BID ADDENDUM NO. 3

CONSTRUCTION NEW GEORGE WYTHE HIGH SCHOOL (RHSA)

**IFB # 23 – 7061 – 11
RRMM Project # 21310 – 00**

**January 4, 2024
Architect of Record:
RRMM, Architects, PC
1317 Executive Boulevard
Suite 200
Chesapeake, VA 23320
Phone: 757-213-6350**

FIRST FLOOR PLAN - AREA 'D' - POWER
SCALE: 1/8" = 1'-0"

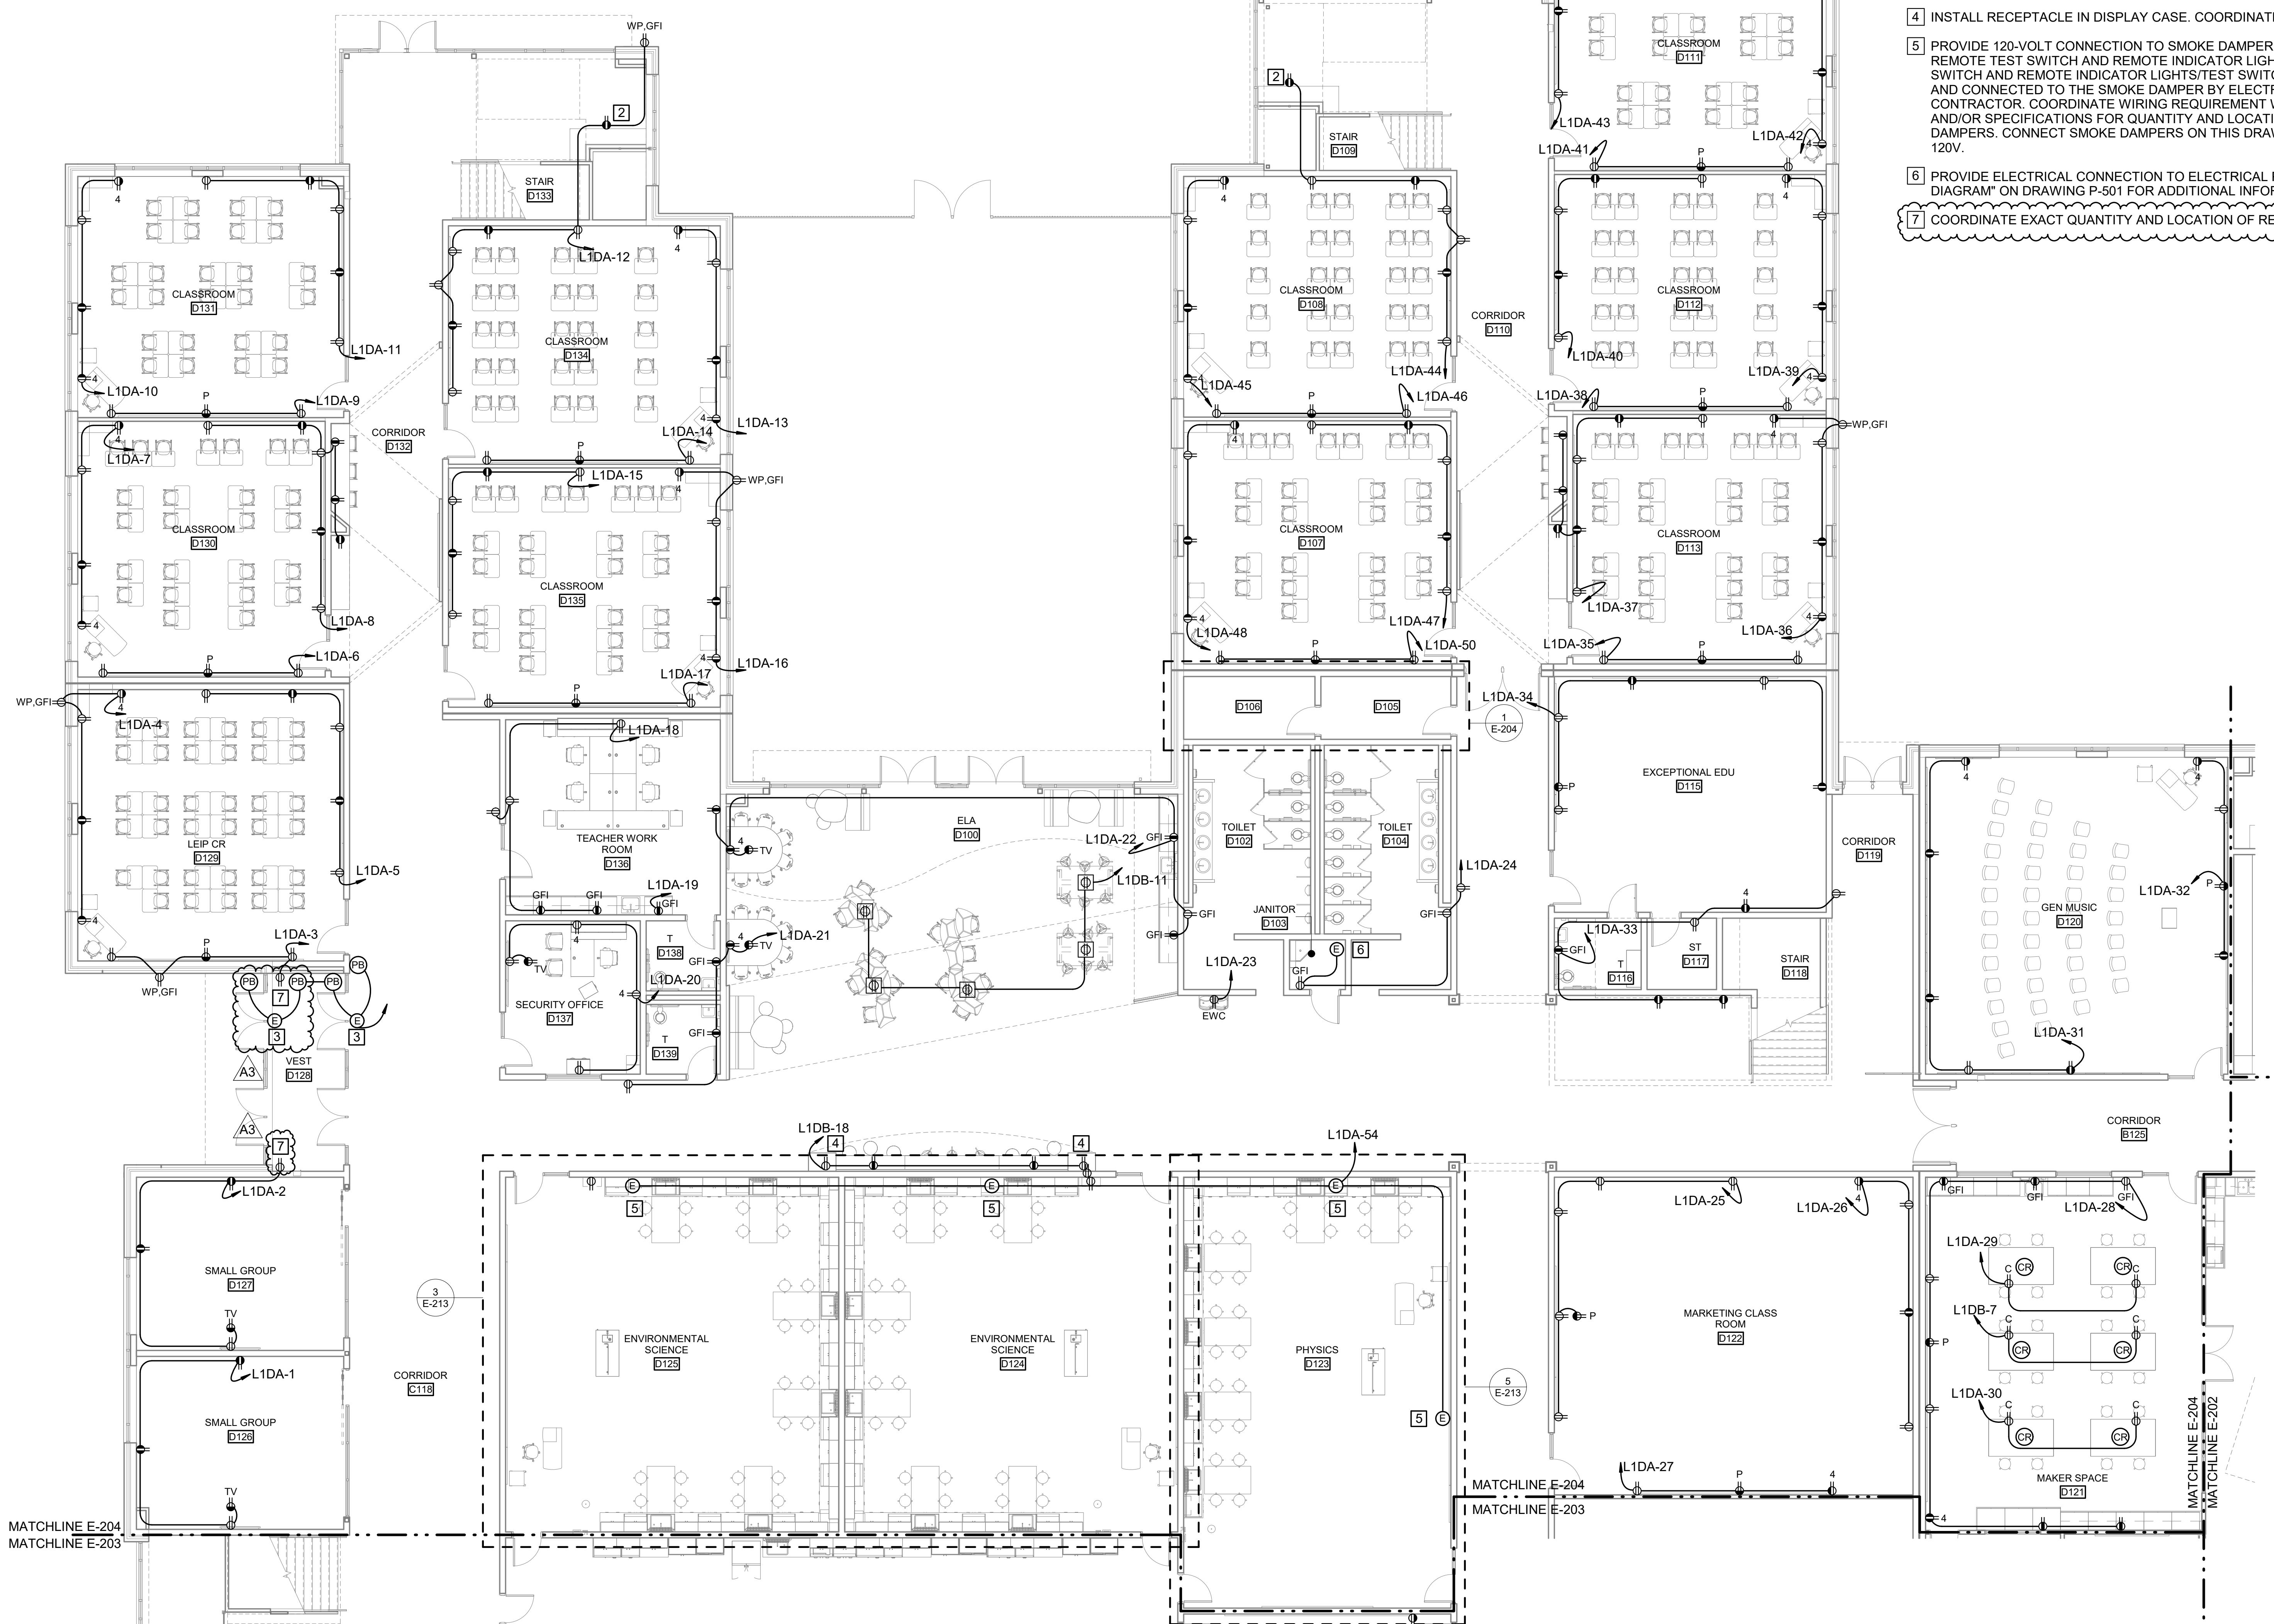
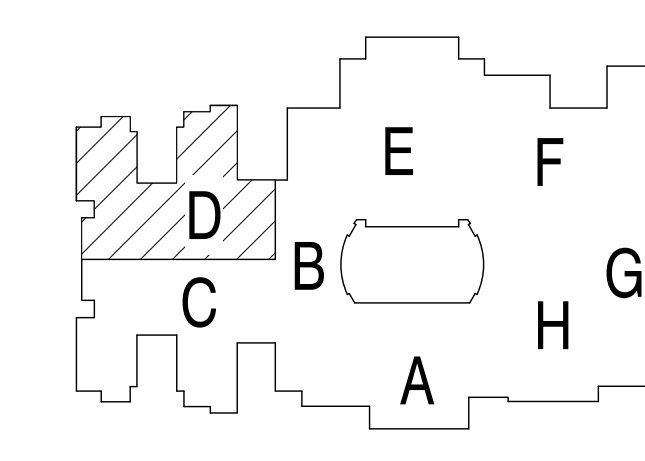
- Construction Notes – **ADD** Keynote 15 per the attached revised sheet.
- 3.21 SHEET E-204 - FIRST FLOOR PLAN – AREA ‘D’ – POWER:
- First Floor Plan – Area ‘D’ – Power – **ADD** keynote 7 to vestibules D128 per the attached revised sheet.

- Construction Notes – **ADD** Keynote 7 per the attached revised sheet.
- 3.22 SHEET E-205 - FIRST FLOOR PLAN – AREA ‘E’ – POWER:
- First Floor Plan – Area ‘E’ – Power – **ADD** keynote 10 to vestibules E136 per the attached revised sheet.

DRAWING: FIRST FLOOR PLAN - AREA 'E' - POWER

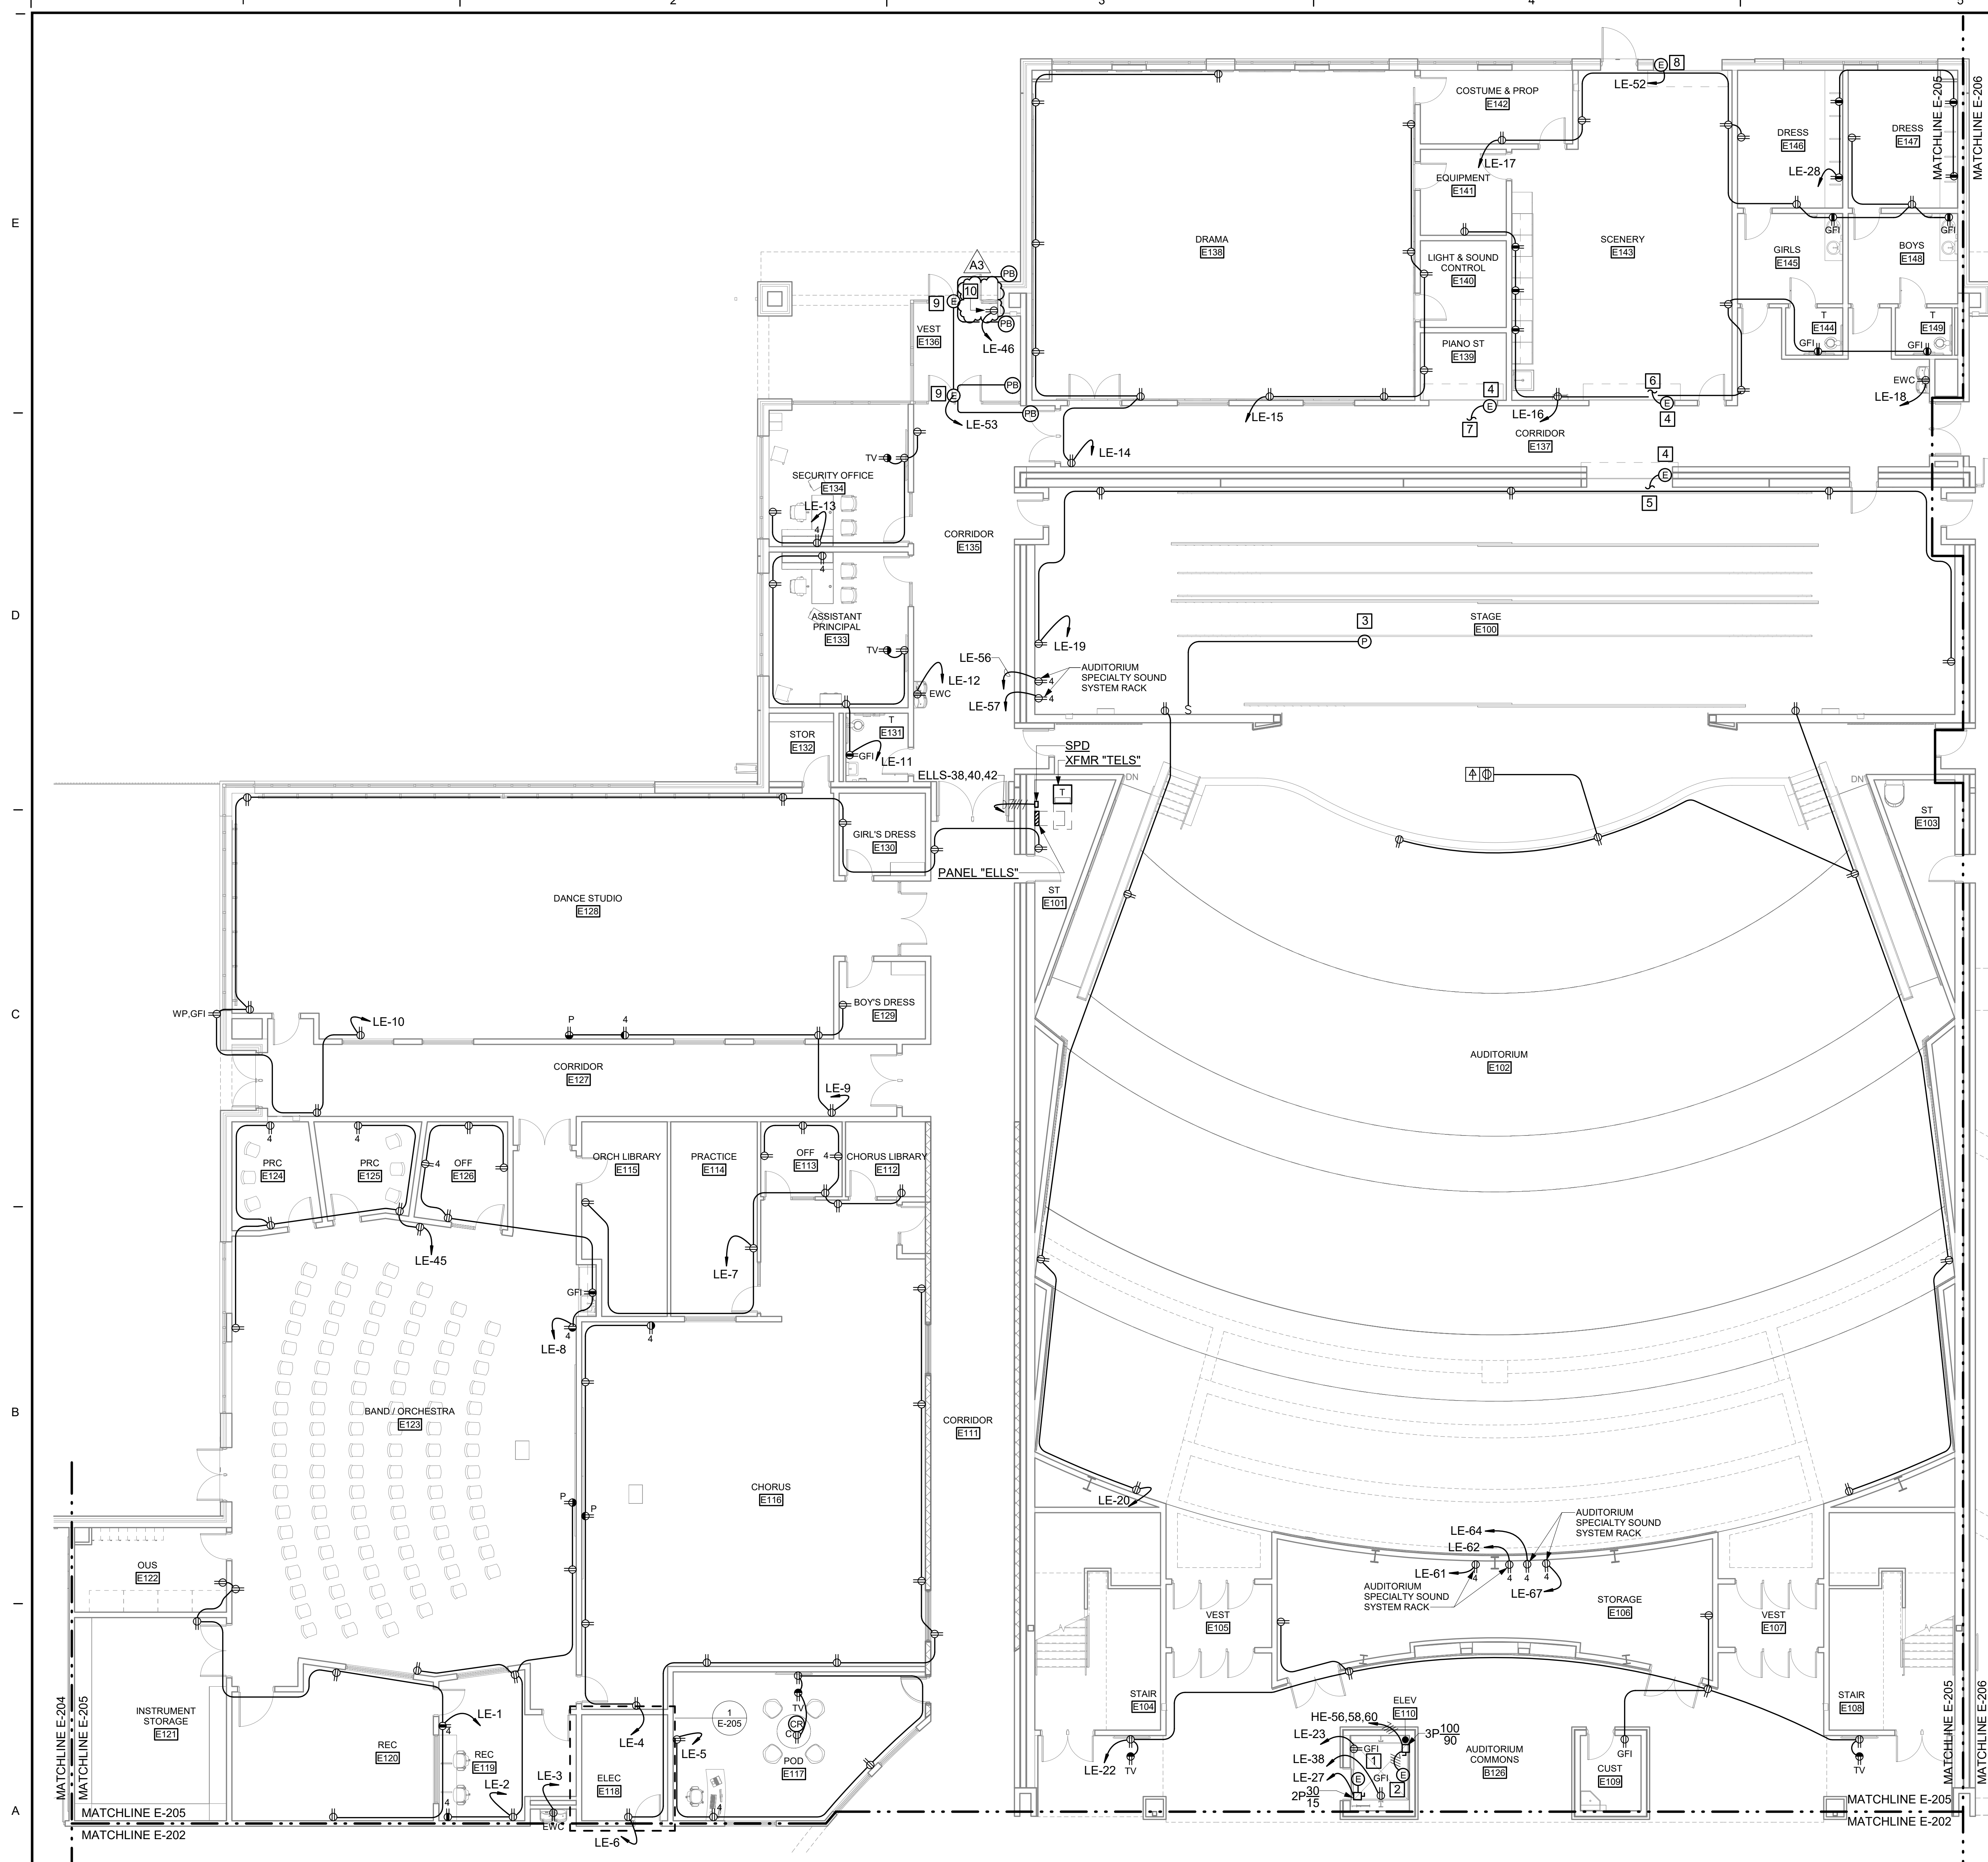
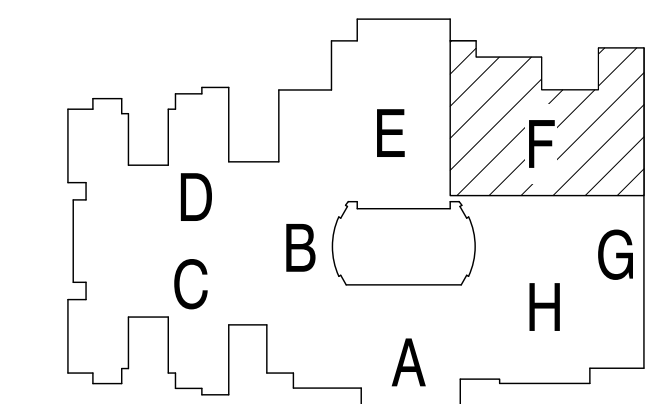
- Construction Notes – **ADD** Keynote 10 per the attached revised sheet.
